PLANNING, ZONING, & BUILDING DEPARTMENT
PZ&B Staff Combination Memorandum: Town Council and Architectural Commission

SUBJECT: ARC-24-0036 (ZON-24-0050) 333 SUNSET AVE (COMBO)

ARC-24-0036 (ZON-24-0050) 333 SUNSET AVE (COMBO). The applicant, Royal Poinciana South, has filed an application requesting Architectural Commission review and approval for the installation of eleven (11) new aluminum shade structures on the 7th-floor apartment balconies requiring Special Exception, Site Plan Review and height variances. This is a combination project that shall also be reviewed by the Town Council as it pertains to zoning relief/approval.

Site plan (blue depicts rooftop locations of aluminum shade structures)

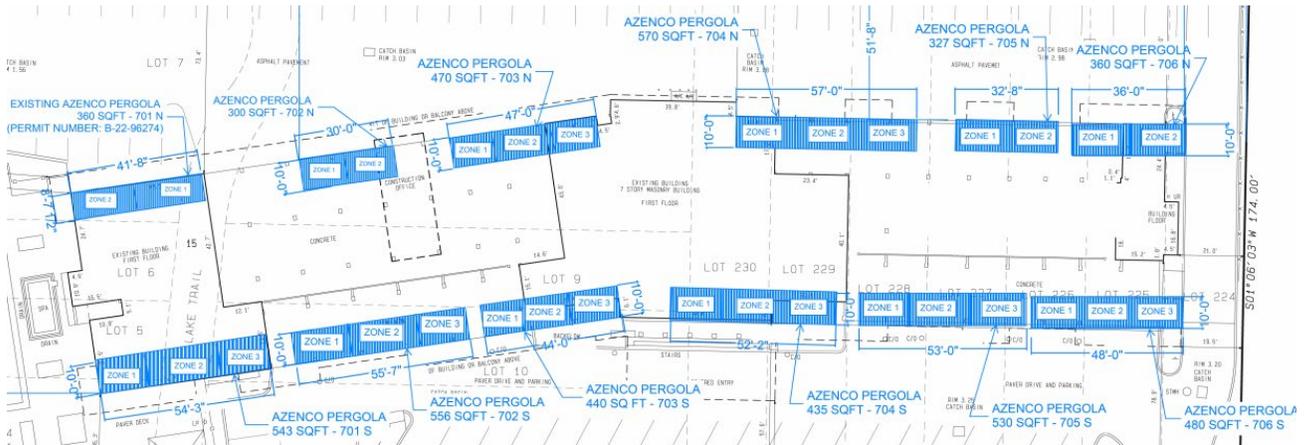
Each of the new proposed aluminum shade structures will match the footprint of the replaced canopy elements and measure a maximum of 9'-7 1/4" high, the precise areas range in size from 360 SF to 556 SF. Note that one of these elements is already installed on the rooftop, at the western edge of the penthouse level, approved under building permit B-22-96274 as part of the prior combo project. B-22-96274 was for "ACCESSORY STRUCTURE: INSTALLATION OF OPEN TRELLIS". It was applied for on 08/31/2022, issued on 12/21/22, and final on 04/13/23.

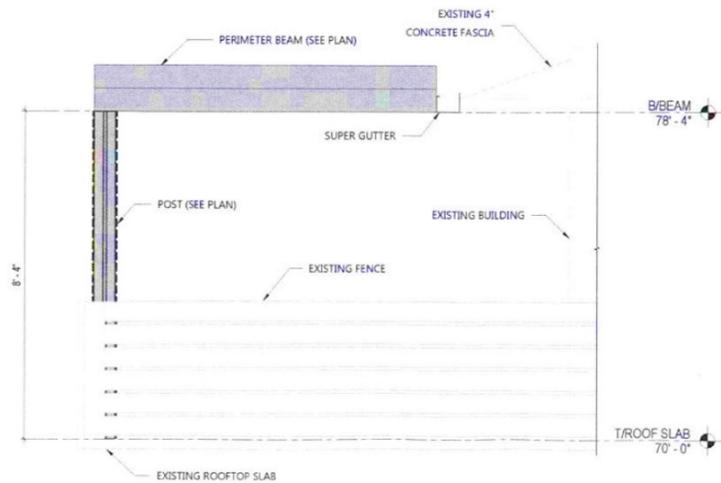
The current aluminum shade structures are proposed to be powder-coated white to blend with the architecture of the building. Two 8” wide vertical posts are proposed to be installed on top of the existing guardrail.

As it pertains to the variance to exceed maximum building height of 62.5’ (and overall height of 67.5’) for the installation of the rooftop structures, the existing building is nonconforming in regard to its height in the R-D (2) district, therefore any introduction of new rooftop elements—trellises, outdoor kitchens, shade structures or even built-in planters—would require a variance.
